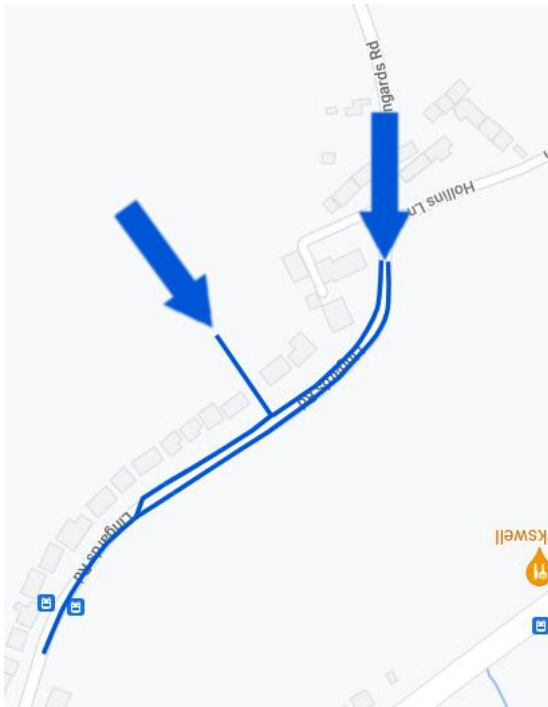
The photograph below shows over an inch of water, flowing down Lingards Road, on the south side of the road.

What is shocking is that this flow of water is only 6 metres from a gully.

That gully is incapable of taking the amount of water flowing down the road (*see image below*), and from the fields between no.92 and no.94: *see image left*.
